APPLICATION FOR PERMIT
DEPARTMENT OF BUILDING INSPECTIONS SERVICES
ELECTRICAL INSTALLATIONS

Original Permit No. 2876007

AMENDMENT TO APPLICATION FOR PERMIT

Notes on Ruth McInnis Home Cliff Island.
Removal of first floor bearing partition 14'0" long.

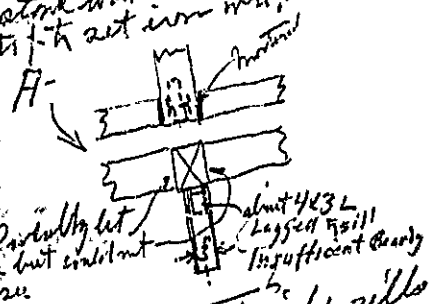
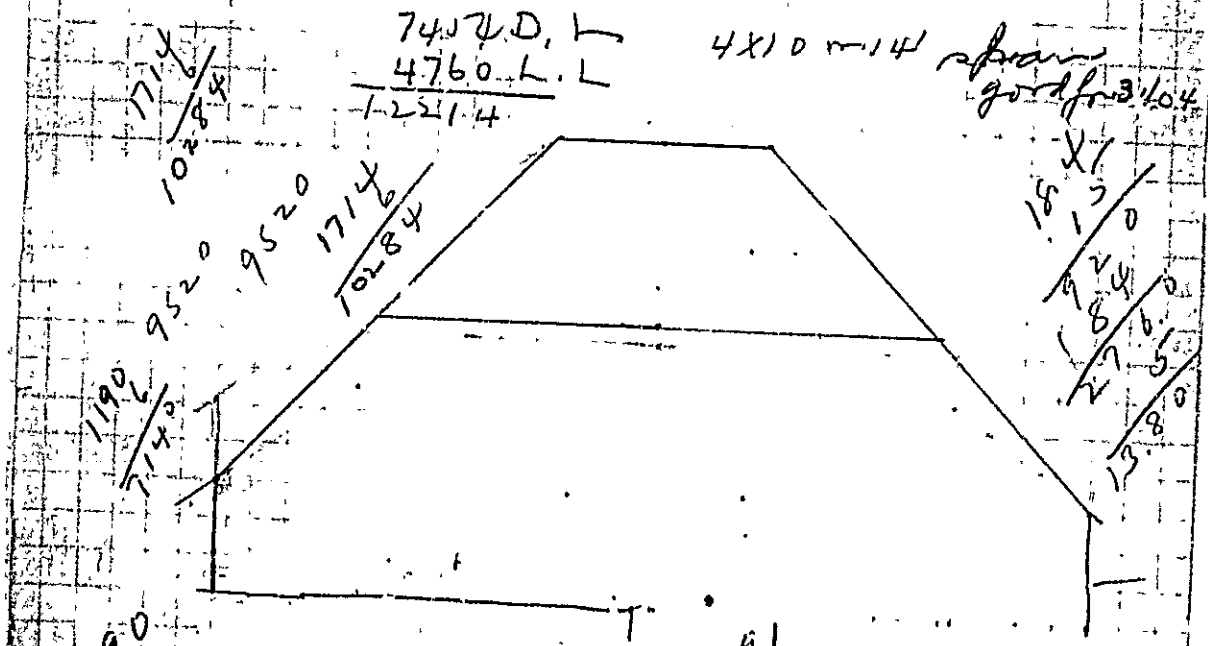
Mr Yeator does not like
 about chimney work
 new front iron bars to be 9' 2" (one
 all cut in, no jacks)

H Rids used along front
 wall to support sill. Looks like
 stone with some concrete on
 top to set iron into, detail at

On the road, sills are
 practically on gravel or ledge
 method of supports for the
 upper sills should all taken.
 joints on S.W. sub look O.K

Sill for Street is 2-2x6, 4-4x4, 4x6
 one piece

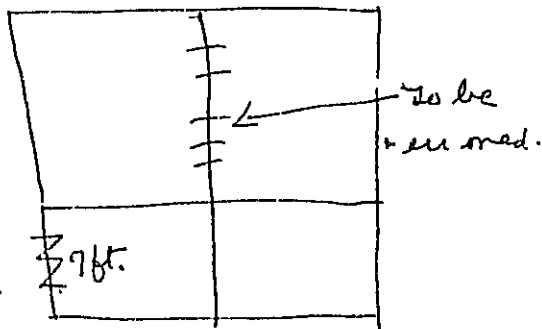
1. To remove a wall as indicated below.

A beam 6x8 to be used supported on either end by 4x6 timbers.

2. To put in a 14' dormer window on East side of house.

I was in error this morning about the roof load. There is no such load coming upon this partition now. May I burden you with perhaps a lengthy explanation of how the size of a supporting beam or girder is arrived at rationally in such a case. We must deal with what we term "dead" load and "live" load. The dead load is the weight of materials in the building that are permanently fastened in place. The dead loads coming upon the proposed beam figure as follows: from the ceiling over the second story about 750 pounds, from the plastered partition over the proposed beam in the second story about 1500 pounds, and from the wood and plaster in the second floor and the ceiling supported under it about 2300 pounds; making a total dead load of about 4500 pounds. This total takes into account no weight for persons, furniture, or storage of any kind in the second story over the proposed girder. Let me say at this point that the 4x10 girder proposed by Mr. Brown if it were to be of spruce or hemlock and full size figures good for only 3400 pounds if you want to feel sure that you will not get sufficient deflection to perhaps crack the plaster in the building. Thus you will see that the 4x10 girder falls at least 25% short of properly supporting the dead weight of materials that we can all be rather sure are being supported by the present partition, which the proposed girder is to replace at the present moment.

However, since you are the owner of the building and now fully understand the circumstances, I feel that I will not be departing from my duty by permitting you to use a timber base on a live load of 10 pounds per square foot on the second floor, which would scale the total load down to 6250 pounds, and with this load it will be satisfactory for you to use a 3x10 full size either Long Leaf Southern Pine or selected Douglas Fir.
